# Product information - BMW brake pads | HELLA

### BMW brake pads

**8DB 355 012-321 / 8DB 355 015-601**

### Changed brake pads

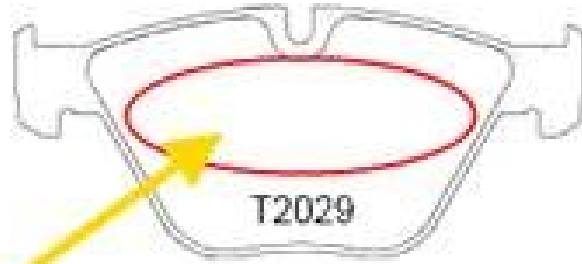
Brake pad 8DB 355 012-321 / T1596 will be replaced by brake pad 8DB 355 015-601 / T2029.

The difference between both brake pads is the missing retaining spring (A) on the brake pad 8DB 355 015-601 / T2029 on the fist side. The missing retaining spring does not have any influence on the comfort conduct of the brake pad.
